McDonnell Douglas (Hughes) and Kawasaki 369 Series Helicopters

AD/HU 369/96
Amdt 1

Engine Control and Warning Systems

Figure 1. Contact Socket Inspection

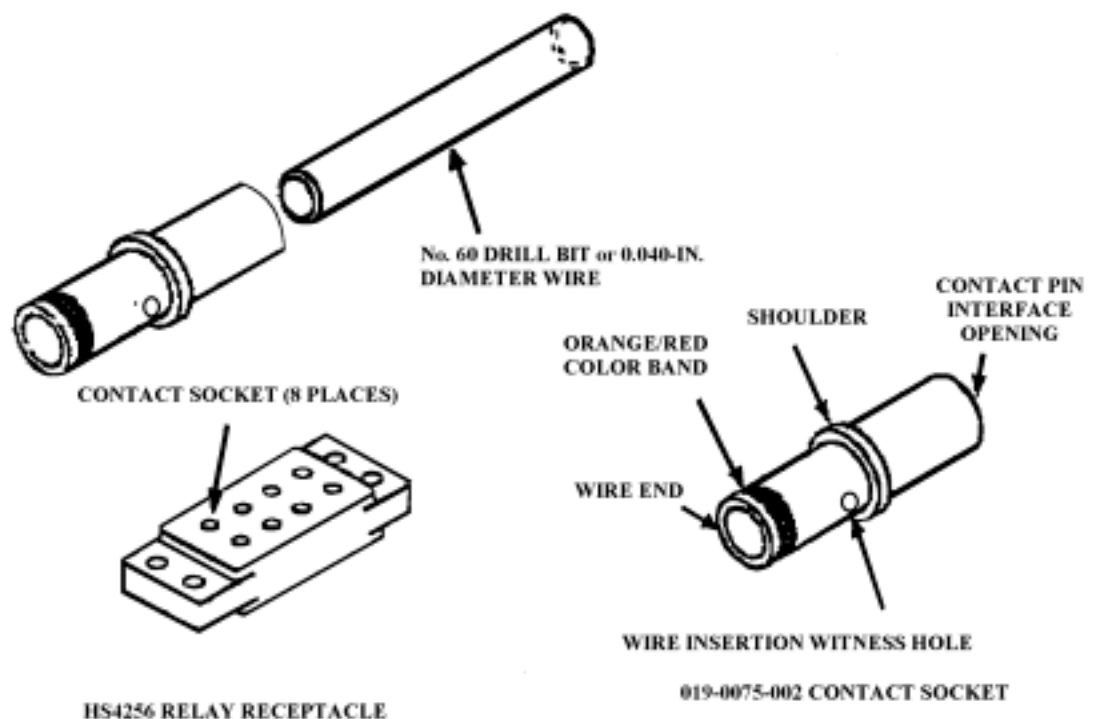
- Requirement: 1. If not previously accomplished, carry out the following:
- Access relays K1, K2, K3, K5, K104, and K200 (relay part number (P/N) HS4240).
 - Remove each relay specified in sub-paragraph (a) from its receptacle (P/N HS4256-1).
 - Using a No. 60 drill bit or a 0.40 inch diameter wire as a gauge, attempt to insert the gauge into every contact socket of each relay receptacle, see Figure 1. (To prevent damage to the receptacle and contact socket, ensure the gauge is inserted perpendicular to the face of the receptacle.) If the gauge can be inserted into the contact socket, the socket must be replaced with a new socket P/N 019-0075-002.
